Flooding & Stormwater Management Planning Report

1-5 Chester Street
Annandale NSW 2038
Lot 11 DP499846

Re: 1-5 Chester Street, Annandale NSW – Planning Proposal – Response to Council Flooding Comments

Annexure A – Amended Conceptual Architectural Section

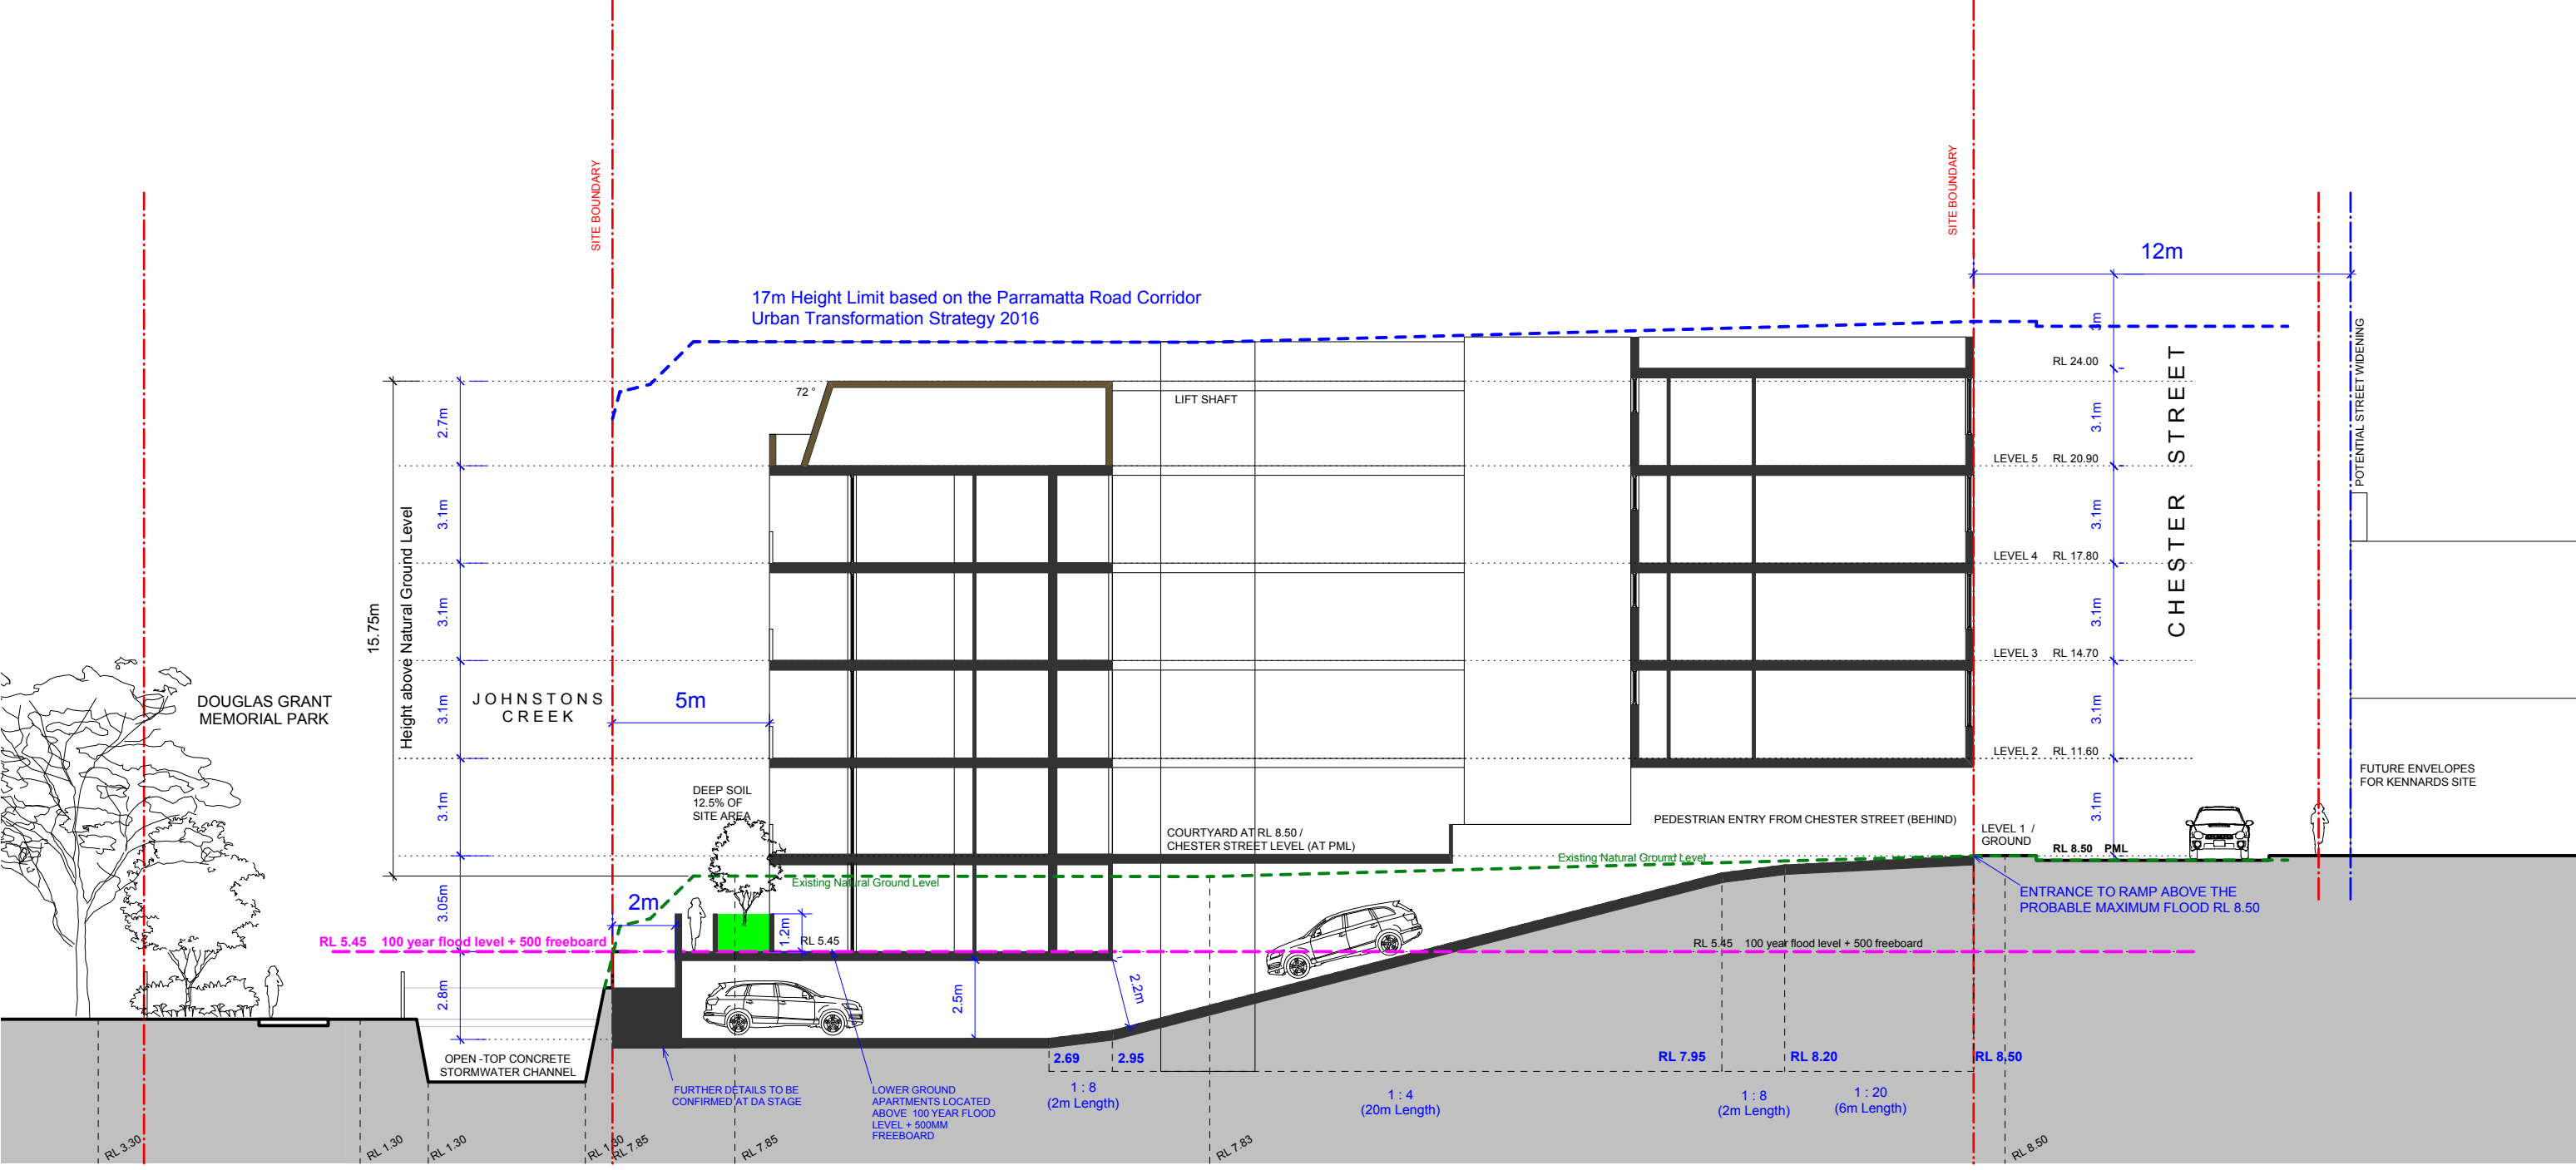
Whilst the proposed western boundary wall could provide the required protection to the development, it would remove flow	It is generally agreed that the undercroft area of the existing development does appear to provide flood conveyance in

<p>capacity alongside the Johnstons Creek channel. This would cause an increase in flows and depths beyond the subject site which absolutely cannot be accepted. Consequently any fence on or close to the boundary would need to be an open style. There should be no solid wall protruding above the existing channel wall within the setback area, including that shown in the UDR cross sections as the upper rear wall of the basement car park.</p>	<p>major storm events, which is partly evidenced by the Cardno flood study that has been undertaken. As the current design is conceptual only and for planning proposal purposes only, a detailed assessment of flooding impacts would be undertaken at a detailed DA submission stage to ensure there are no detrimental effects to upstream and downstream properties and that the existing flooding regime is maintained. To convey this intent revised conceptual architectural plans have been prepared and are located in annexure A for reference.</p>
